Regional Municipality of Durham

Bid Opportunity: T-1032-2021 – Relocation of Oral Health Clinic to 200 John Street, Oshawa

Addendum number 2 – May 6, 2021

1 ELECTRONIC DOOR LOCK ROUGH-IN DETAIL
E-003 SCALE: NTS

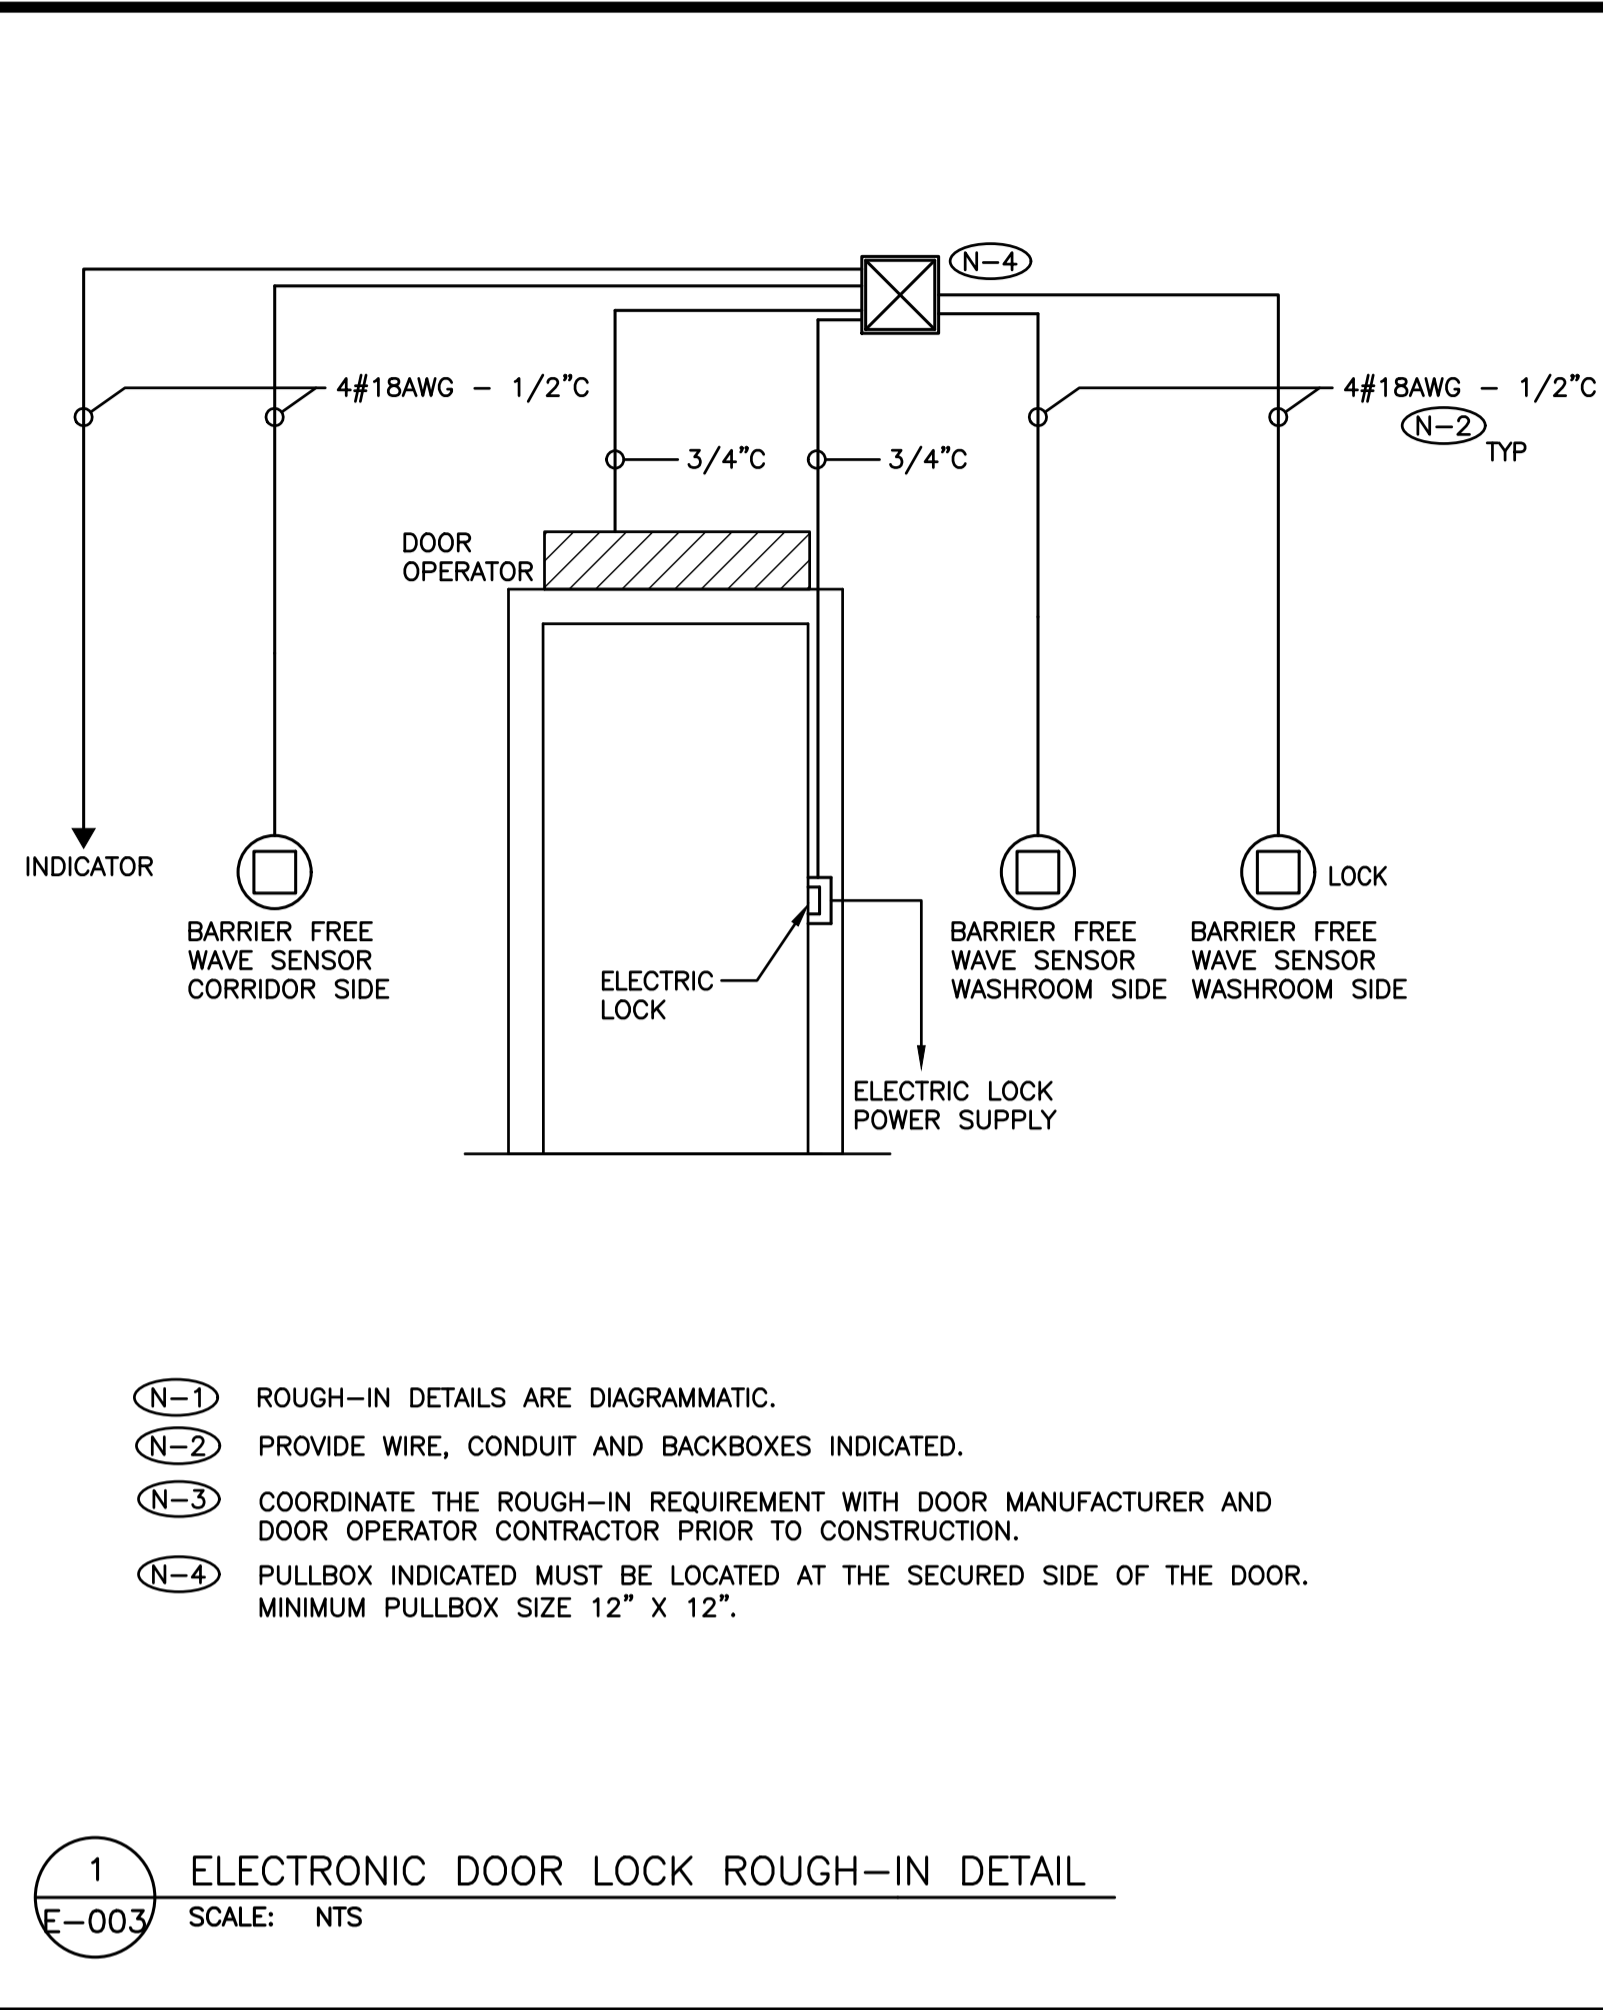
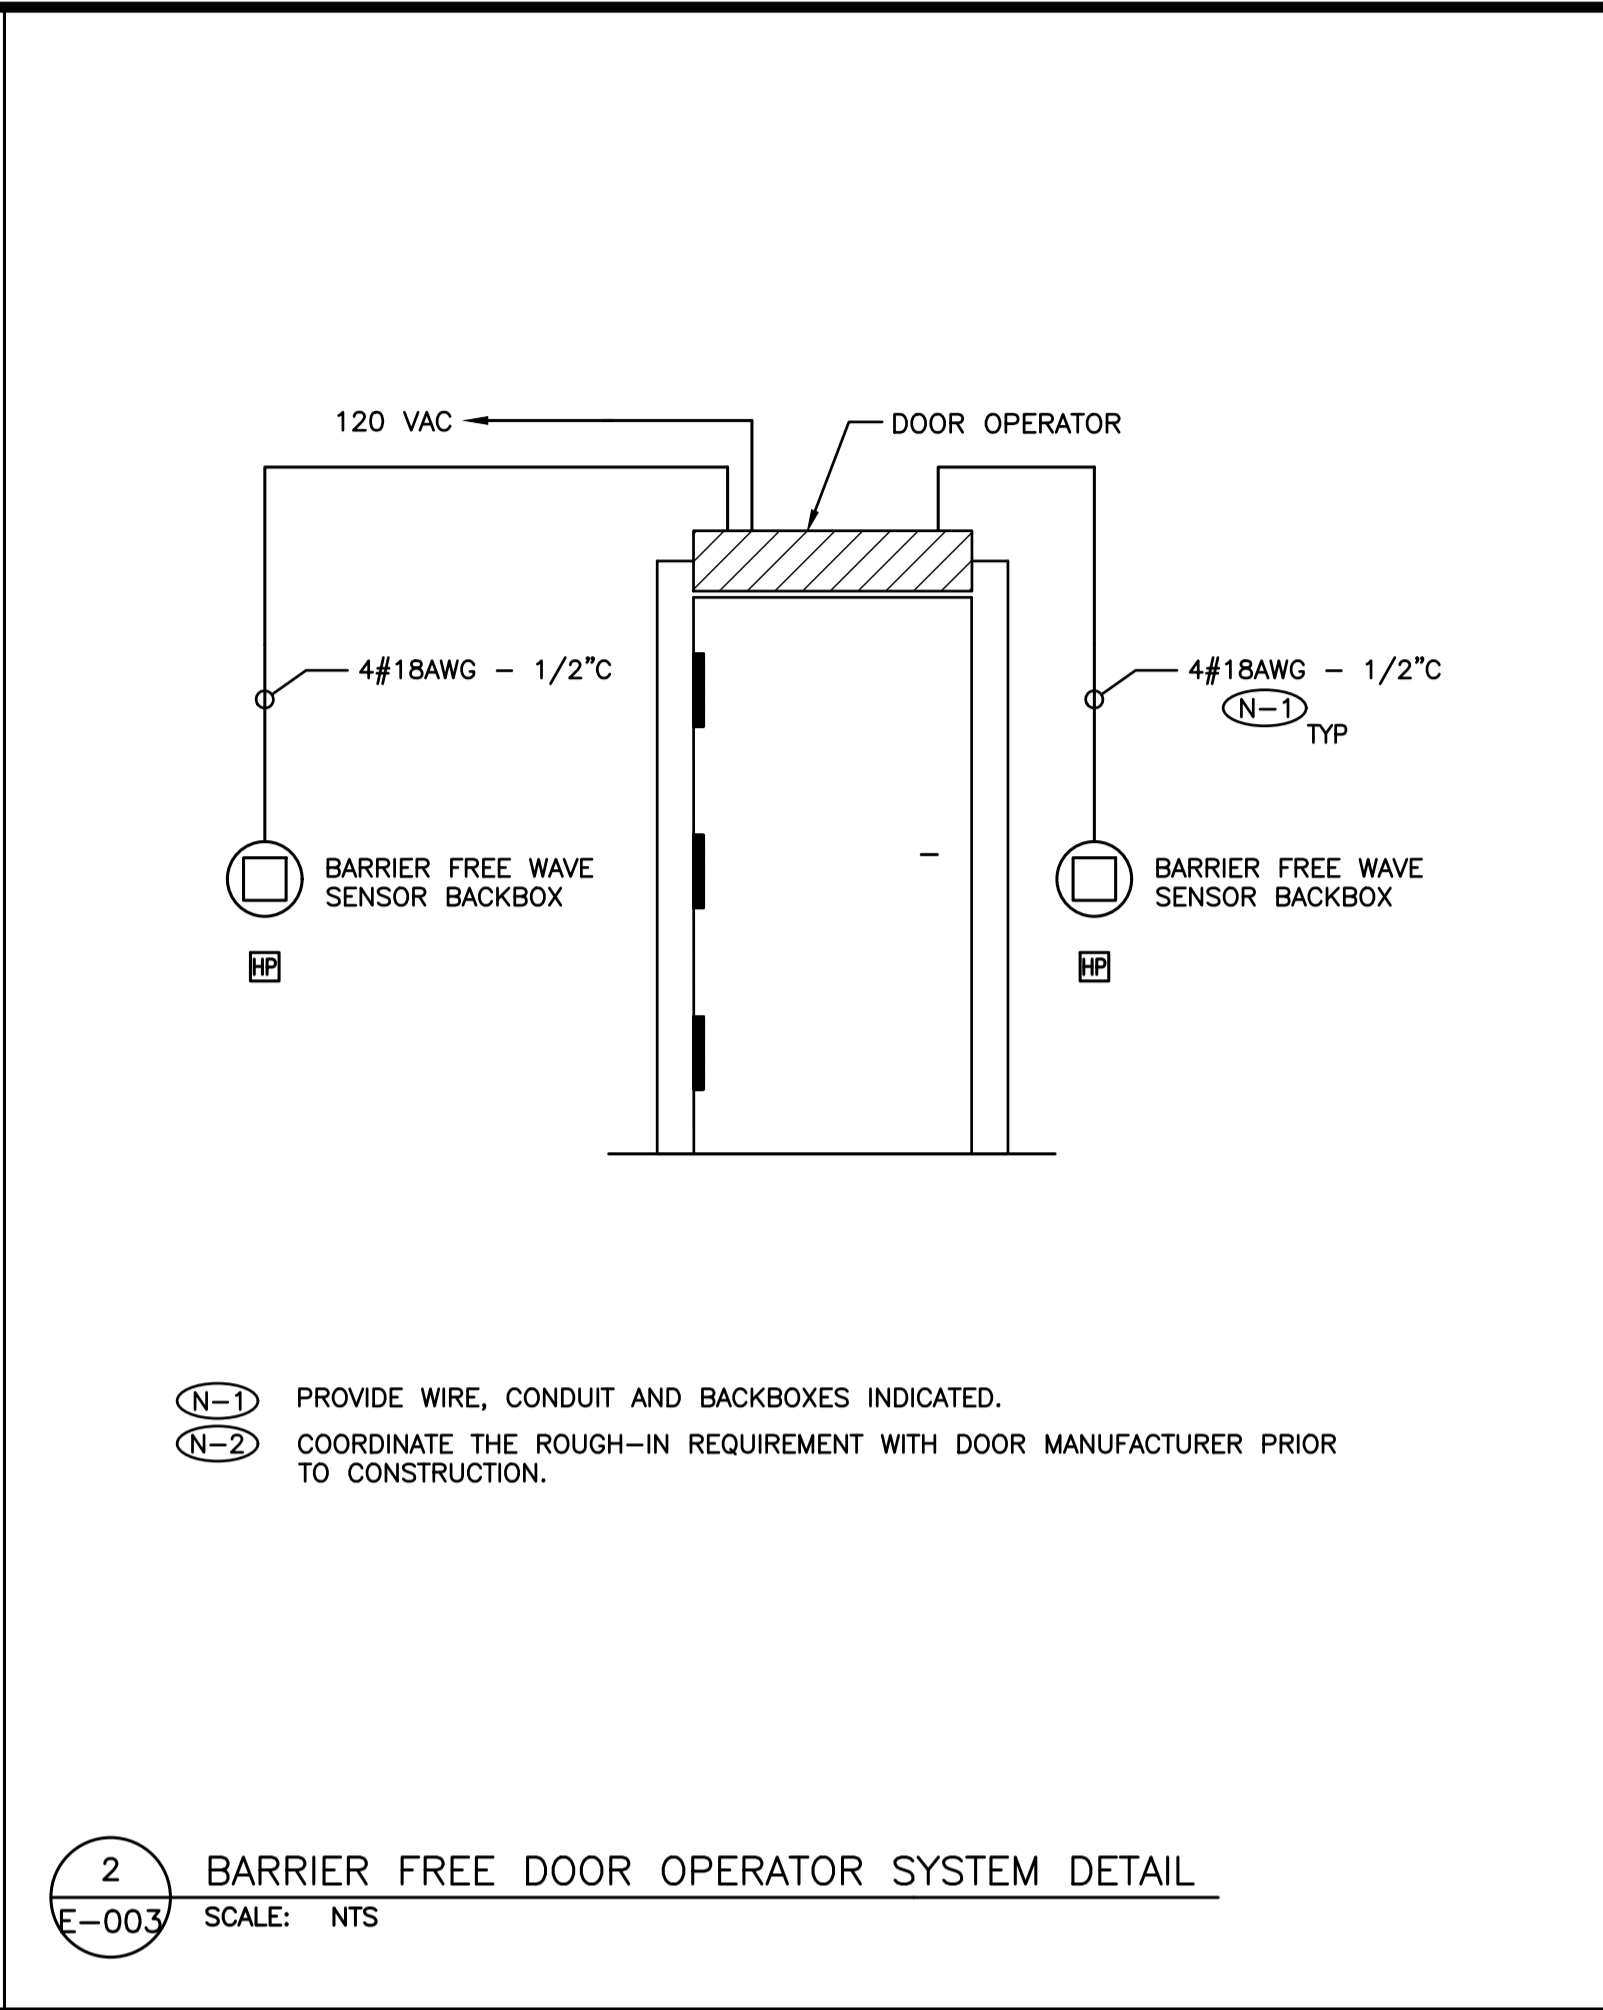
- .2 Drawing E-003 has been modified as part of this addendum.
 - .1 Updated detail number 3.

1 CARD ACCESS CONTROL SYSTEM ROUGH-IN DETAILS
E-004 SCALE: NTS

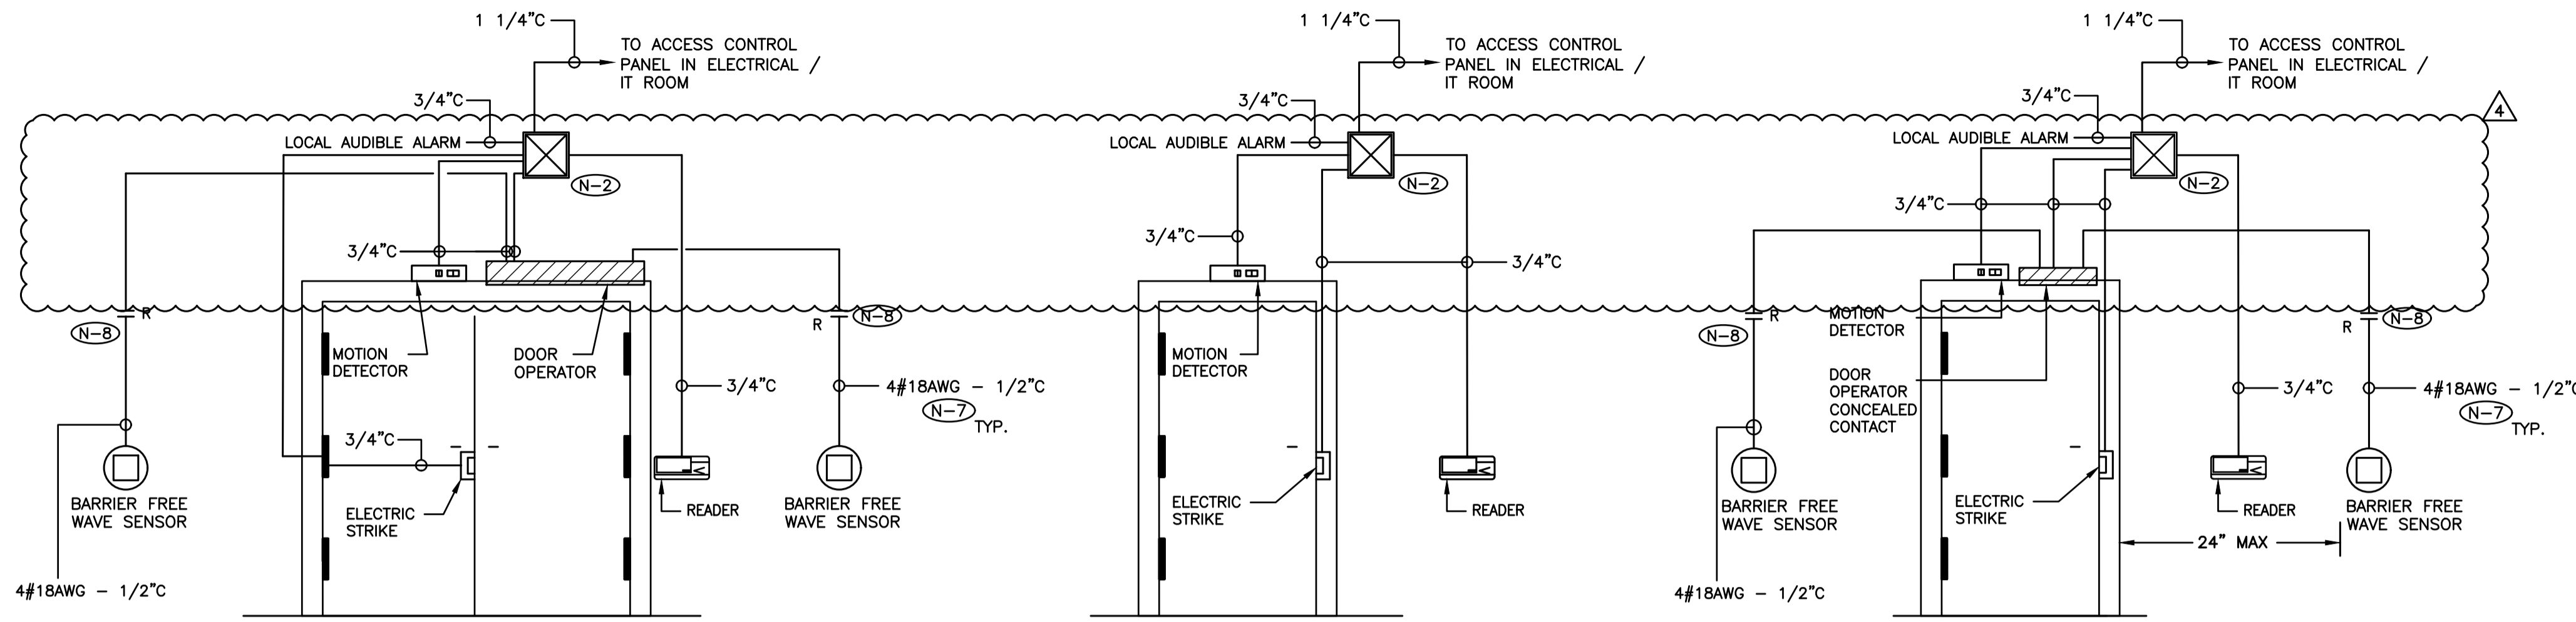
- .3 Drawing E-004 has been modified as part of this addendum.
 - .1 Updated detail number 1.

4 PARTIAL BASE BUILDING FIRE ALARM SYSTEM RISER DIAGRAM
E-005 SCALE: NTS

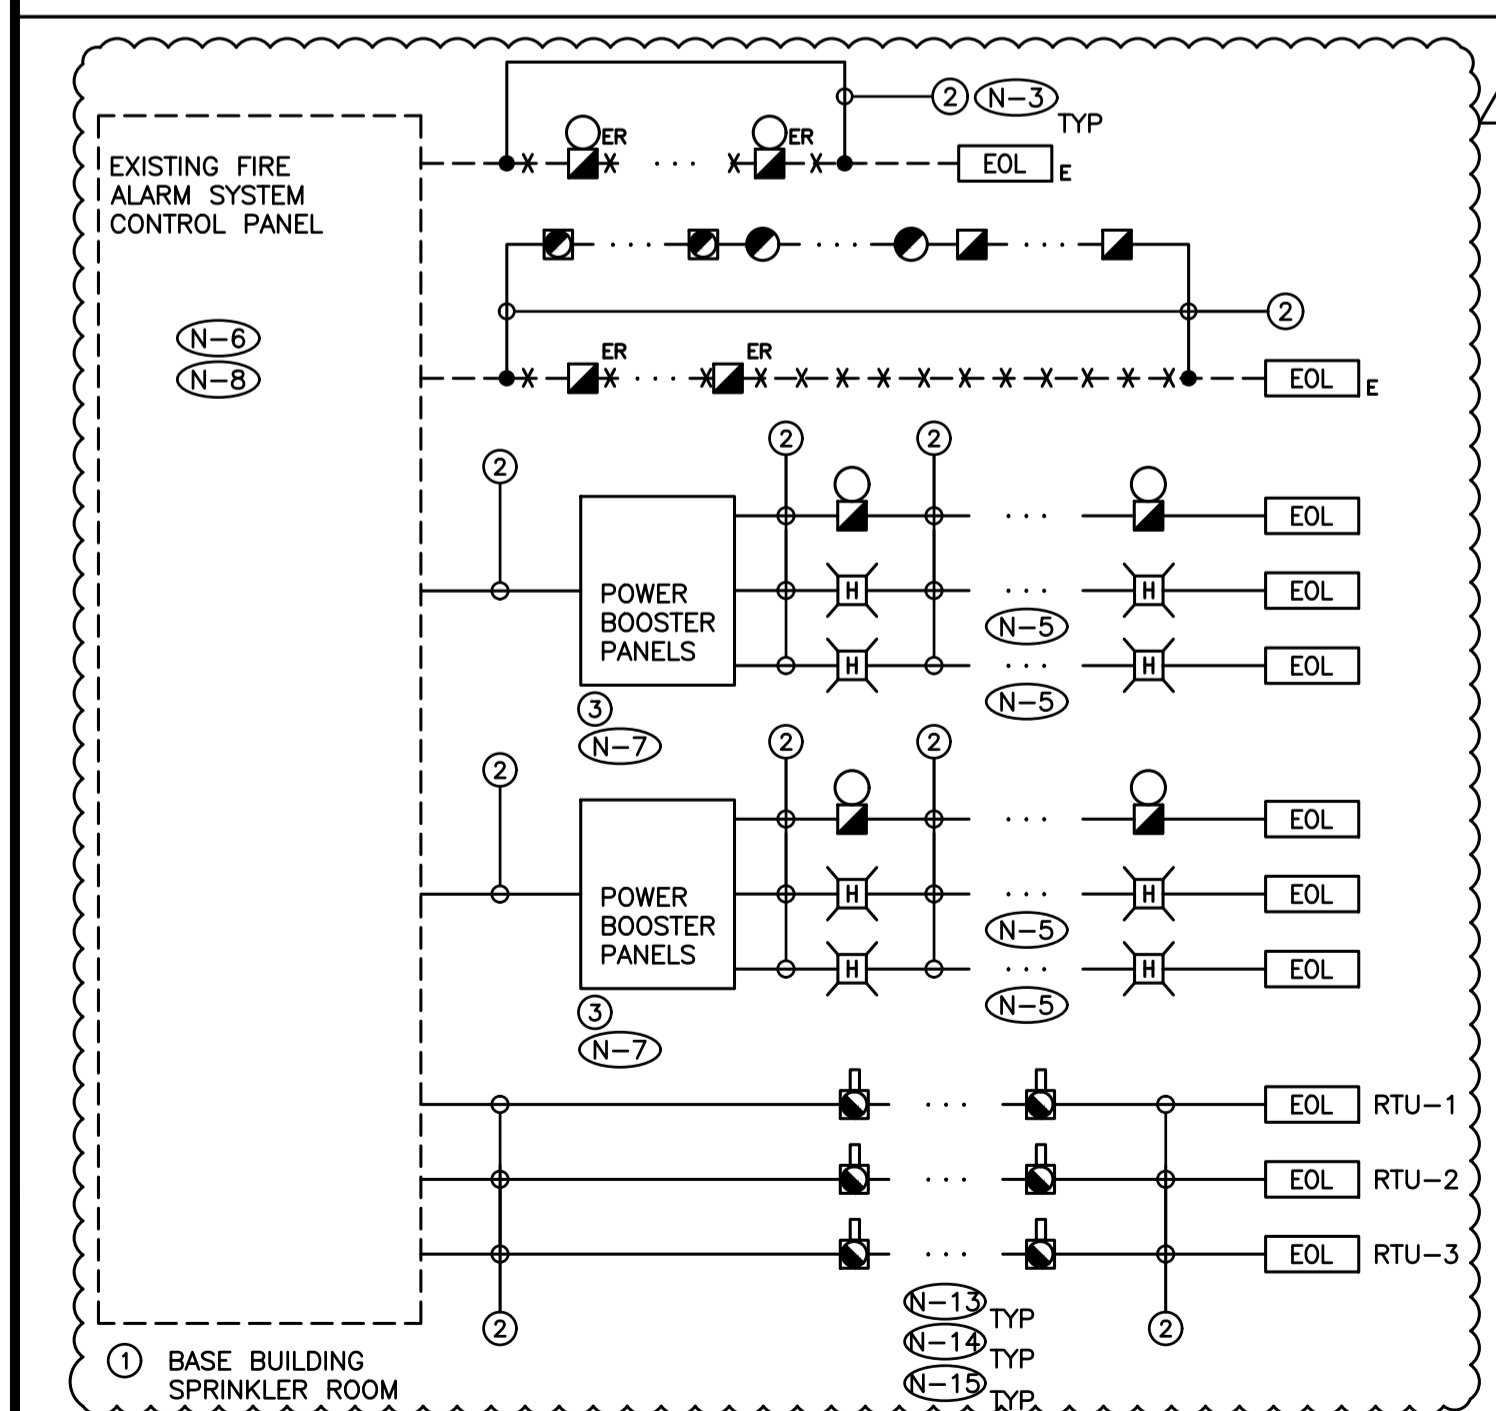
- .4 Drawing E-005 has been modified as part of this addendum.
 - .1 Updated detail number 3 and 4.
